Access Compliance Report Public Rights-of-Way (Curb Ramps)

Main Street: MARTHA_ANN_DR Cross Street: BRIMHALL_DR Location: NE

ADA ID: RPRK211207120252 Ramp Type: Type 1 - Perpendicular Diagonal Initial Pass/Fail: Pass Overall Compliance: No Severity Score: 16

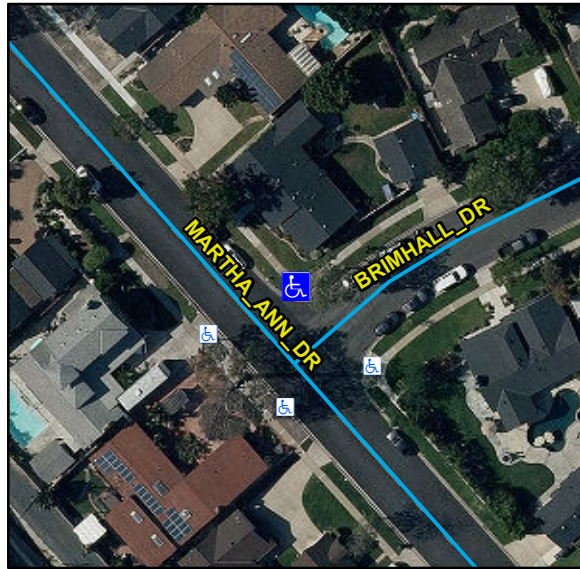
Compliance	Description	Data	Compliance	Description	Data
N/A	Ramp Length (in)	85	N/A	Flare Type LT	
Yes	Ramp Width (in)	54			Sloped
Yes	Ramp Run Slope (%)	6.2	N/A	Flare Slope LT (%)	4.8
No	Ramp Cross Slope (%)	3.1	N/A	Flare Traversable LT	No
N/A	Landing Present	Yes	N/A	Flare Type RT	
N/A	Landing Length (in)	48			Sloped
Yes	Landing Width (in)	54	N/A	Flare Slope RT (%)	6.4
Yes	Landing Run Slope (%)	0.5	N/A	Flare Traversable RT	No
No	Landing Cross Slope (%)	2.6	No	DWS Provided	No
N/A	Landing Movement Obstructed?	No	N/A	DWS Contrast	N/A
	Landing Movement Type	N/A	N/A	DWS Length (in)	N/A
N/A	Landing Shared	No	N/A	DWS Full Width	N/A
N/A	Clear Space	Yes	N/A	DWS Offset Left (in)	N/A
N/A	Clear Space To Crosswalk (in)	48	N/A	DWS Offset Right (in)	N/A
N/A	Marked Crosswalk 1	No	N/A	Marked Crosswalk 2	No
	Crossing 1 Direction	W		Crossing 2 Direction	S
	Marked Crosswalk 1 Width (in)	N/A		Marked Crosswalk 2 Width (in)	N/A

N/A	Ramp Inside Crosswalk 1	N/A	Yes	Ramp Inside Crosswalk 2	N/A
	Crossing 1 Slope (%)	8.5		Crossing 2 Slope (%)	5.2
	Crossing 1 Cross Slope (%)	3.2		Crossing 2 Cross Slope (%)	1.6
No	Gutter Ponding	Yes	N/A	Curb Slope	6.2
Yes	Gutter Lip Height (in)	0		Road Run Slope (%)	2.5
No	Gutter Run Slope (%)	6.2		Road Cross Slope (%)	9.5
No	Gutter Cross Slope (%)	2.8			
Yes	Overall Surface Condition: Acceptable		No	Perp Joint Present	No
	Cross Gutter Present?	No		Spandrel Present?	No
	Replace Cross Gutter?	N/A		Replace Spandrel?	N/A

Remove & Replace Curb Ramp With Two New Directional Ramps or Equivalent. Remove & Replace Gutter.
